PROJECT: No: 201504  
**ISLAND BAY ROAD HOUSE**

**From:** Emma van den Eykel  
**Sent:** Tuesday, 17 April 2018 9:40 a.m.  
**To:** Determinations  
**Subject:** FW: Expert Report: 6 Island Bay Rd, Beachlands (Ref 2975) [UNCLASSIFIED]

## STRUCTURAL GLAZING COVER LETTER

# BUILDING CONSENT APPLICATION – ADDITIONAL SUBMISSIONS REVIEW

CROSS SECTION 3 3  
S-02

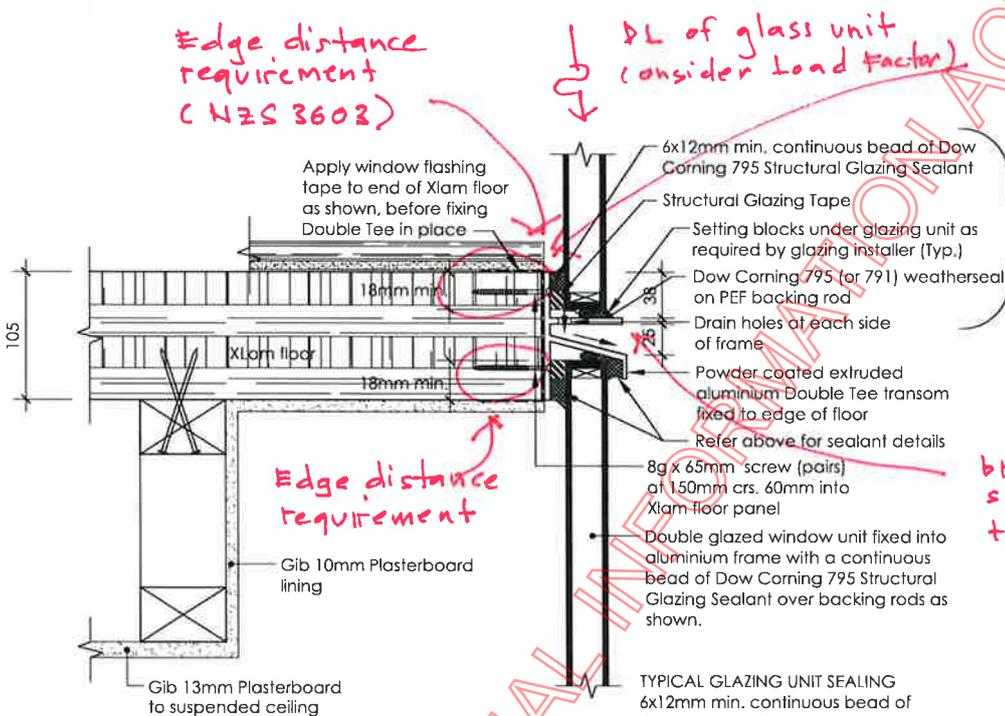
mullion shows no STS behind (please confirm)

WINDOW ABOVE AND BELOW FIRST FLOOR

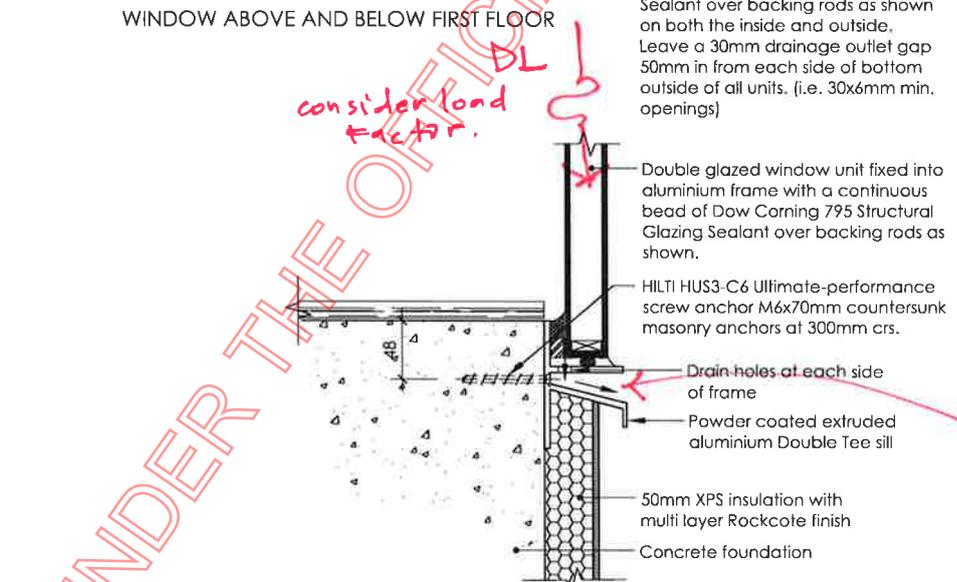
Edge distance requirement (NZS 3603)

DL of glass unit (consider load factor)

screws both subjected to tension (wind) and shear (DL)

Edge distance requirement

bracket subjected to bending.

WINDOW AT GROUND FLOOR

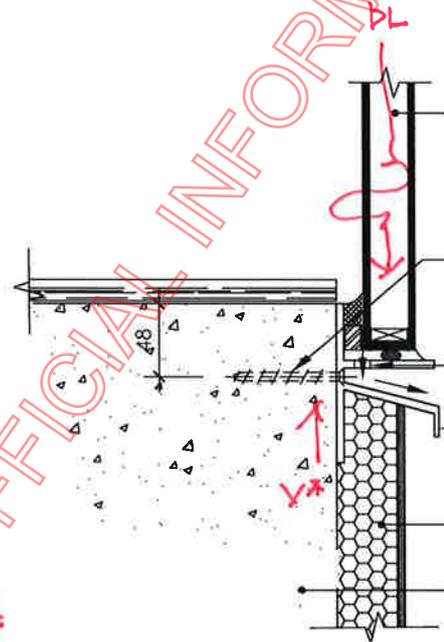
DL consider load factor.

(screw subjected to both tension and shear)

bracket subjected to bending.

note: draft determination report (page 3) shows a different type of bracket.

wt. of panel (Lower half) =  $3.02 \times \frac{18}{1000} \times 25.5 = 1.39 \text{ kN/m}$   
 $\times 1.35 = 1.87 \text{ kN/m}$

shear load per screw

$V^* = 1.87 \text{ kN/m} \times 0.30 = 0.56 \text{ kN}$

From Hilti manual  
(H453-C6)

Shear, seis = 6.99 kN, ok

WINDOW AT GROUND FLOOR

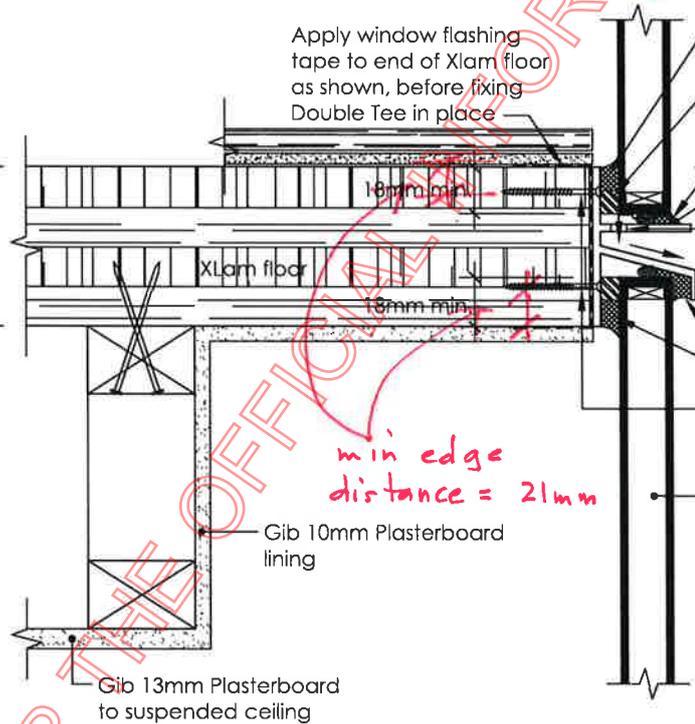
no data on sill transom.

$$\text{wt. of panel (upper half)} = 2.975 \times \frac{18}{1000} \times 25.5 \times 1.55$$
$$= 1.84 \text{ kN/m}$$

check 8g screw at 150 mm spacing

$$V^* = 1.84 \times 0.15$$

$$= 0.28 \text{ kN}$$

From W253603

For 8g screw (2x)

$$= 2 \times 0.7 \times 0.67 \times 105$$
$$= 1.61$$

$$= 1.51 \text{ kN } \underline{\text{ok}}$$

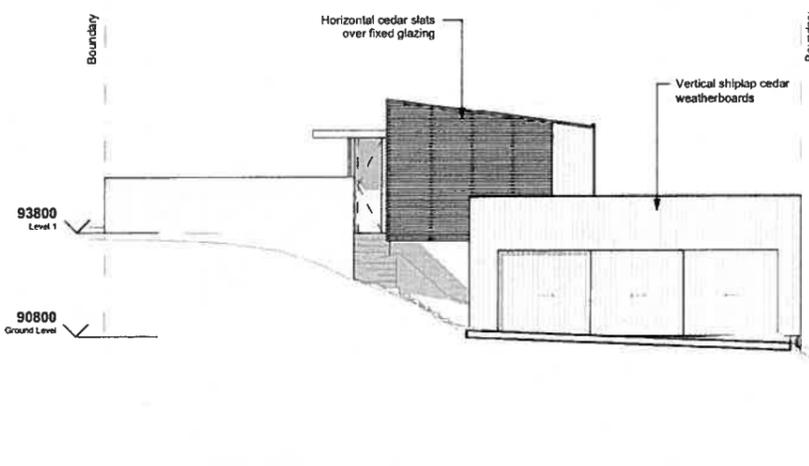
not all 'T' mullion have SHS post behind.

structural bite ( NZS 4223)

$$\text{bite} = \frac{0.5 \times 2300 \times 1.76}{241}$$

$$= 8.40 \text{ mm}$$

tensile strength of Dow Corning 795

plus 2mm installation tolerance.

$$\text{total bite width} = 10.40 \text{ mm} > 9.50 \text{ mm}$$

NG

CONFIRM THICKNESS
